Cassington Parish Council Responses to Submissions For Deadline 7 and Closing Statement

Cassington Parish Council's Responses to Botley West Solar Farm Applicant's Responses to other D5 Submissions (REP6-049)

Figure 1. Proposed scaling back of the Botley West proposed solar arrays north of Cassington and Worton. Areas in red hatch are where solar arrays from the proposal are removed.

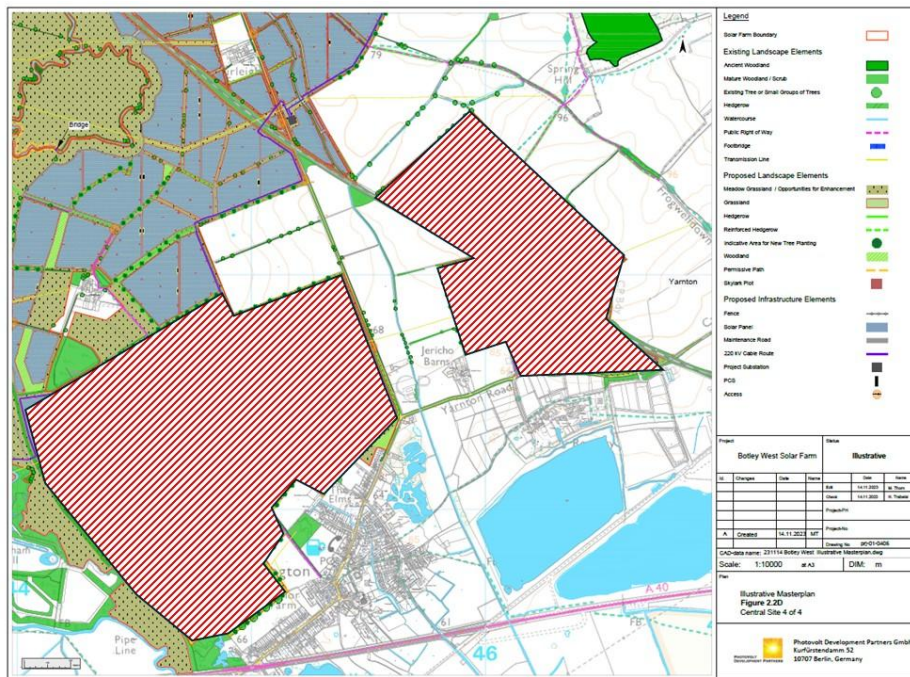
Cassington Parish Council are therefore proposing that either the Botley West proposal is rejected which remains both the Parish Council's and resident's favoured option, or it is scaled back from the north of the village to the summit of the hill contours that lie to the north of the village. A rough sketch of what this would look like is indicated in Figure 1 below.

This proposal has the advantage of moving the entire scheme back from Cassington village where we believe that it is far too close to dwellings in the village. This will help to preserve amenity of at least some of the public rights of way from Cassington and Worton. It also avoids issues around the potential alterations to local temperature that may occur as a result of conversion of solar energy to heat by the vast array of panels across the landscape. It also preserves some of the greenbelt and farmland that would otherwise be lost.
